CONTRACT NO. 1836

FURNISH AND INSTALL DEAERATOR

ADDENDUM NO. 1

000-SU-01
SITE UTILIZATION PLAN

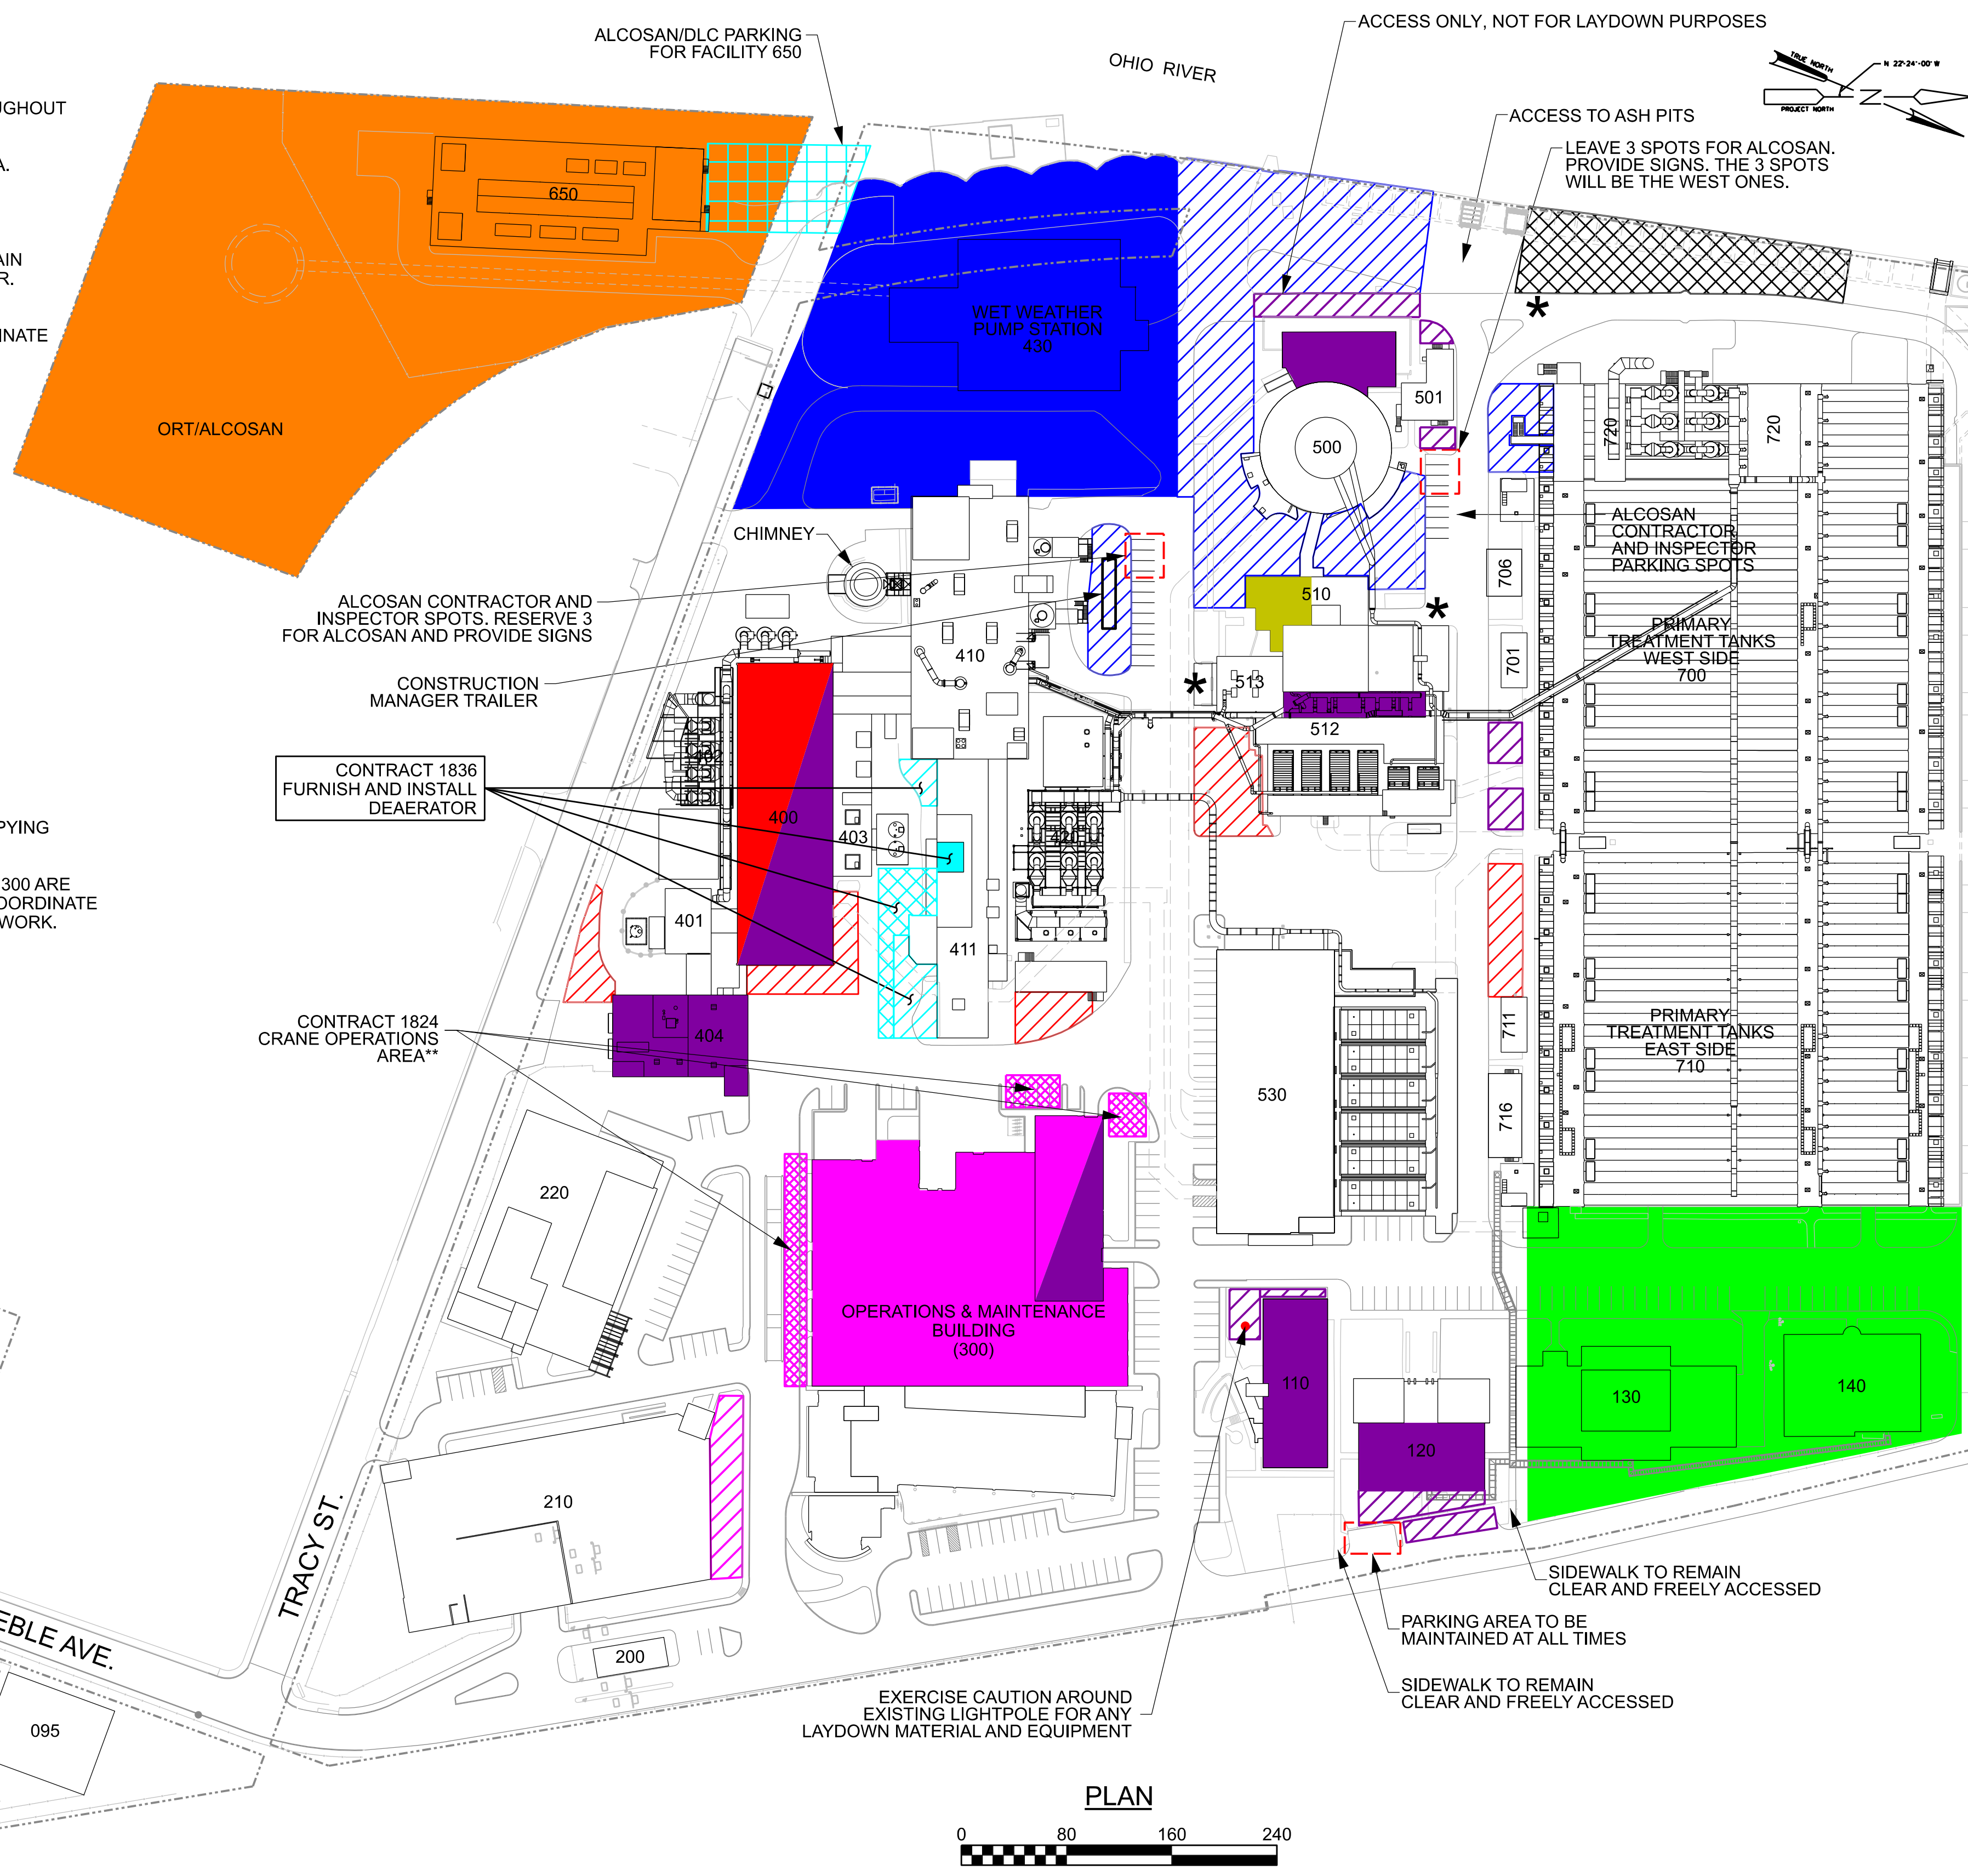
- a) Replace the existing Site Utilization Plan (000-SU-01, Rev. 0) with the attached revised version (000-SU-01, Rev. 1). See the “Questions” section below for more details.

Answer: Yes, additional area will be available to the contractor to use during the specific period of time that their crane is on-site. The attached Site Utilization Plan has been revised to show this additional area.

Answer: The tunnel is shown on the attached site utilization plan (in faint gray dashed lines). It diagonally connects the lower left portion of the 411 building with the lower right portion of the 400 building.

1. TRAFFIC CONTROL TO BE IN OPERATION WHILE CRANE IS OCCUPYING ANY AREA OF NORMAL TRAFFIC FLOW.
2. CRANE OPERATIONS AREAS TO THE WEST AND NORTH OF BLDG 300 ARE RESERVED FOR SHORT-TERM MOBILITY OF UP TO ONE WEEK. COORDINATE CRANE LOCATION WITH OWNER PRIOR TO COMMENCEMENT OF WORK.
